ISSUE: Permit to Demolish/Capsulate (partial) and Certificate of Appropriateness for alterations

APPLICANT: Jemal's 515 King LLC

LOCATION: Old and Historic Alexandria District
515 King Street

STAFF RECOMMENDATION

Figure 3: King Street proposed colonnade encapsulation

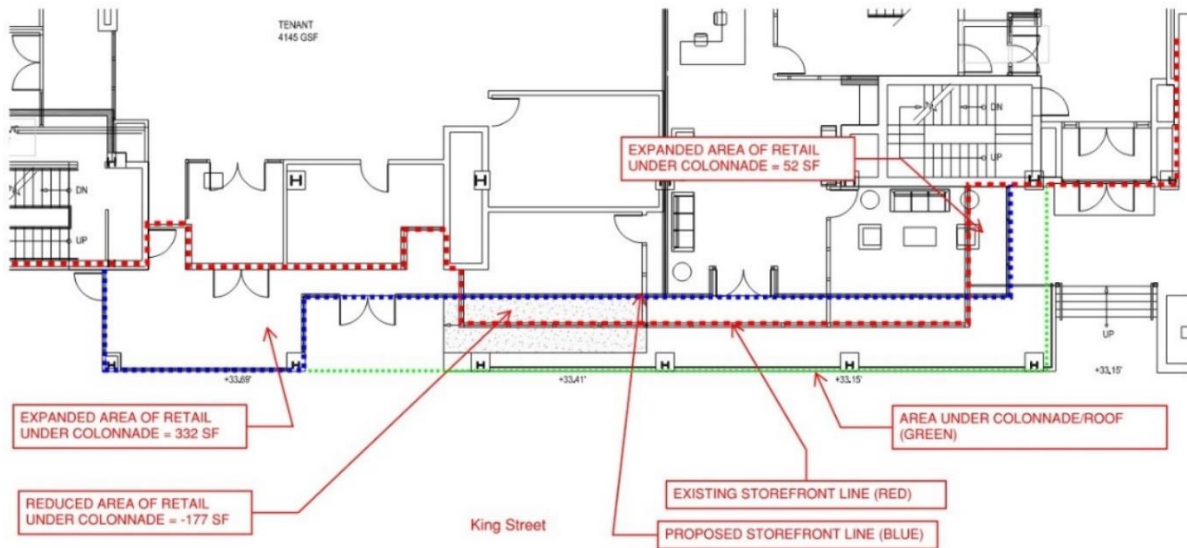
- Demolish approximately 642 square feet of masonry to add windows; see Figures 1 & 2.
- Encapsulate approximately 553 square feet of space to expand/enclose area under the first-floor colonnade and add an ADA ramp; see Figures 3 & 4
- Remove a portion of the roof over the 5th floor roof deck; see Figure 1

Similarly, enclosing portions of the colonnade will also enhance the appearance. See Figures 10 & 11. The design for enclosing the colonnade entails removing a portion of the raised concrete slab along King Street in order to deepen the colonnade in this location to add an ADA ramp and railing. See Figure 3 for the plan. The railing will be steel and could be approved administratively. This ramp and railing fulfill the *Design Guidelines* criterion that “Accessibility ramps and structures should not hide, obscure or cause the removal of historic architectural details.” The new storefront windows will be aluminum, clear, non-reflective, and without tint, therefore complying with the “Alexandria New and Replacement Window Performance Specifications in the Historic Districts.” Staff notes that the signage depicted in the application materials is merely for illustrative purposes. This application does not propose any signage on the building. The proposed 3’ metal and glass awning/canopy to be cantilevered over the main entrance on King Street also complies with the *Design Guidelines*. It is “...appropriate and sympathetic to the historic style of the building to which they (sic) are attached.” It also represents a great improvement over the existing twenty-year-old fabric awning, which is showing its age.

1 Enlarged Sign Elevation

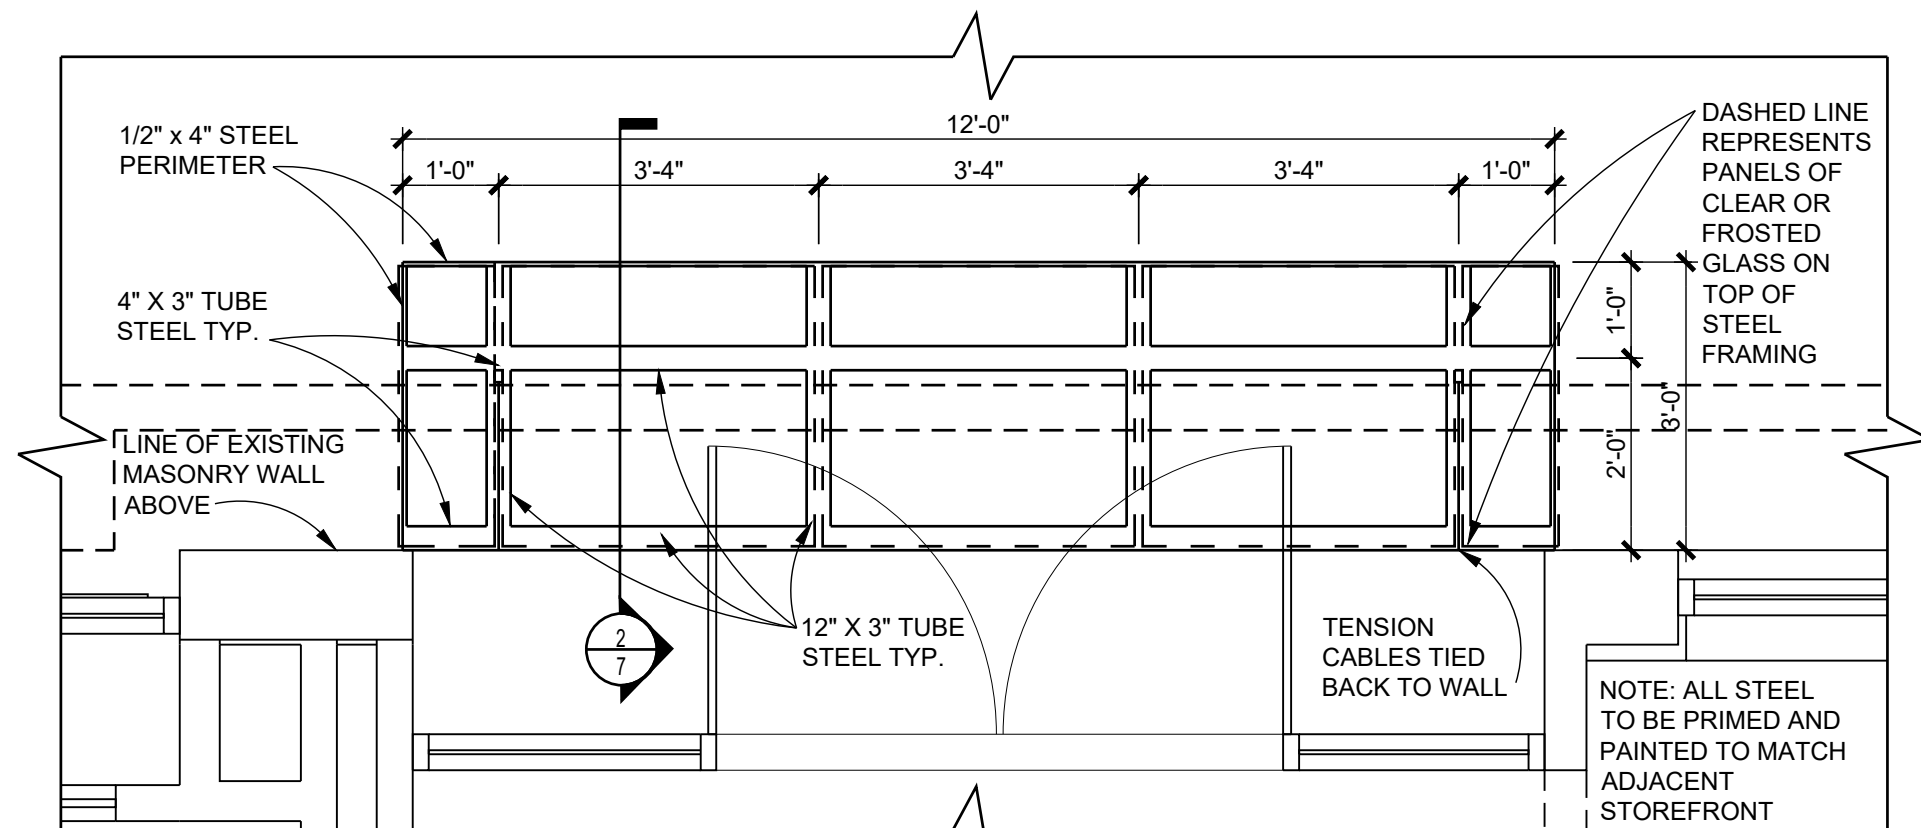
The proposed “515” sculpture/sign designated for the planter near the King Street entrance does not comply with Zoning. It is over 9’ tall and the maximum allowed height is 6’ tall, which includes the planter itself. Staff therefore recommends that the applicant return to the BAR at a future hearing with a new application for an updated sculpture design.

1. For the proposed paint/stain, the applicant shall utilize Option 2, using stain instead of paint and only staining the proposed gray portions (corner elements and precast concrete).
2. Install the door canopy at the King Street entrance in the mortar joints, as noted in the application materials.
3. The applicant shall return to the BAR at a later date with a separate application for the "515" sculpture/sign.
